Service Bulletin

Subject: COOLANT LEVEL WARNING LIGHT COMES ON	Bulletin No: 01-040/10
	Last Issued: 07/13/2010

- This bulletin supersedes the previous bulletin 01-006/09 issued on 02/10/09. The APPLICABLE MODEL(S)/VINS, REPAIR PROCEDURE, PART(S) and WARRANTY INFORMATION have been revised.
- Changes are noted below in Red beside the change bar.

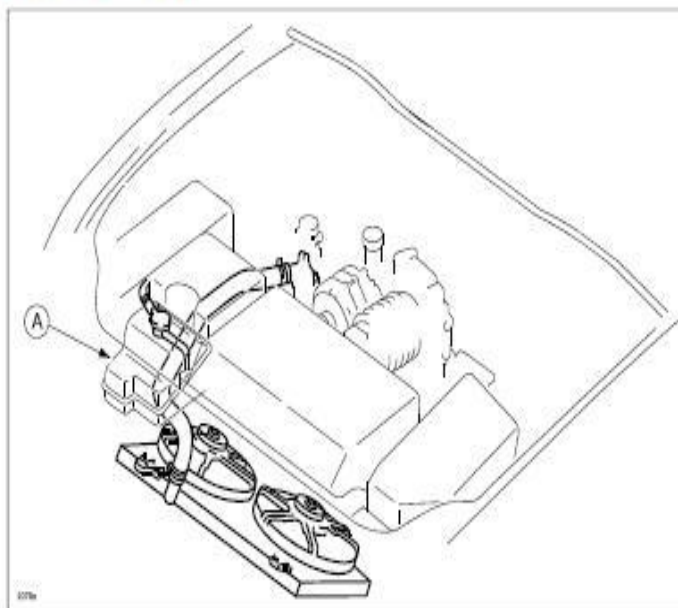
The coolant level sensor float in the coolant reserve tank (A) is deteriorated and absorbs coolant. The float gets heavy, and sinks, causing the the coolant level warning light comes on. As a mass-production change, the design of the float has been modified.

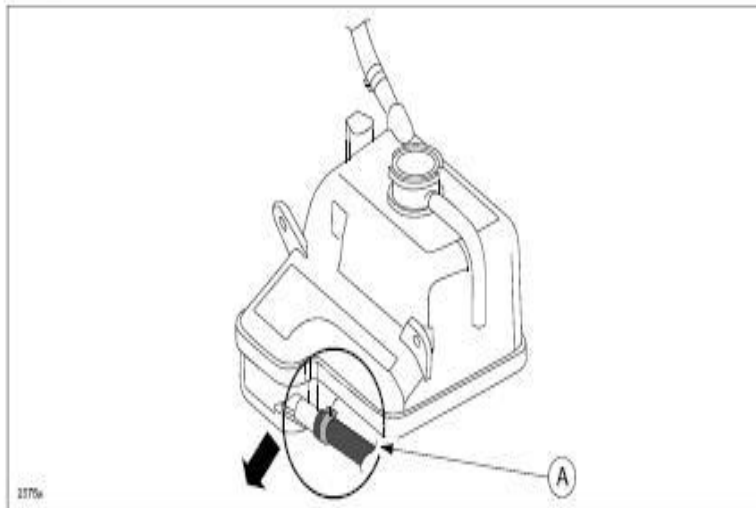
2. Replace the coolant reserve tank (A) with a modified one. Refer to MS3 online service information or Workshop Manual section 01-12 - COOLANT RESERVE TANK REMOVAL/INSTALLATION [13B-MSP].

NOTE: When removing the water hose (A) from the reserve tank, remove from the radiator upper tank side first, then remove the reserve tank side. Otherwise the nipple on the radiator upper tank may break.

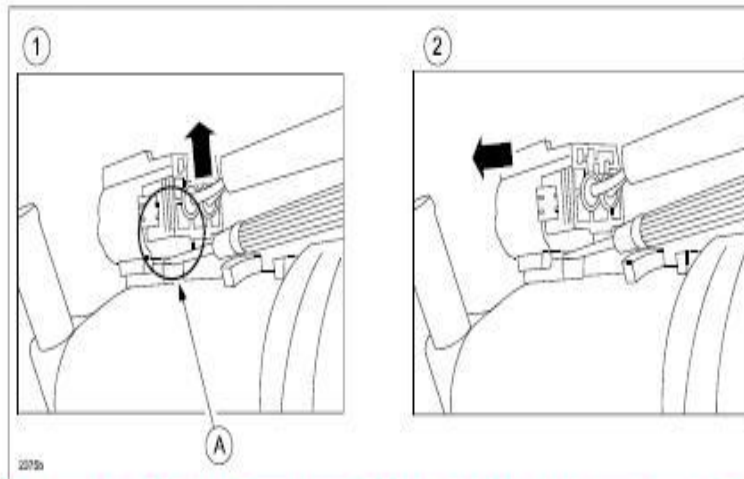
- a. Remove the cooling system cap from the coolant reserve tank; the cap will be reused.
- b. Remove the sensor connector from the tank by (1) inserting a flat screwdriver underneath the connector and push up, then (2) slide the connector forward.

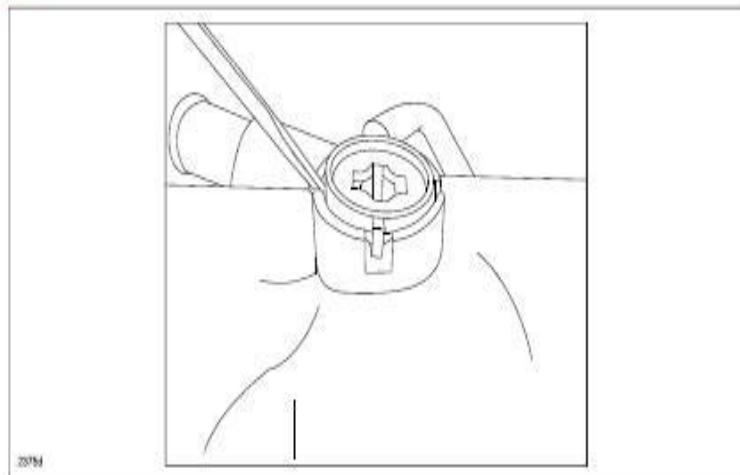
- c. Use a flat screwdriver to pry the sensor loose (on both sides) from the coolant reservoir; the sensor will be reused.

NOTE: If the sensor is hard to remove, cut the dotted line (A) as shown (both sides) using cutting pliers, then remove the sensor from the coolant reserve tank using a flat screwdriver (B).
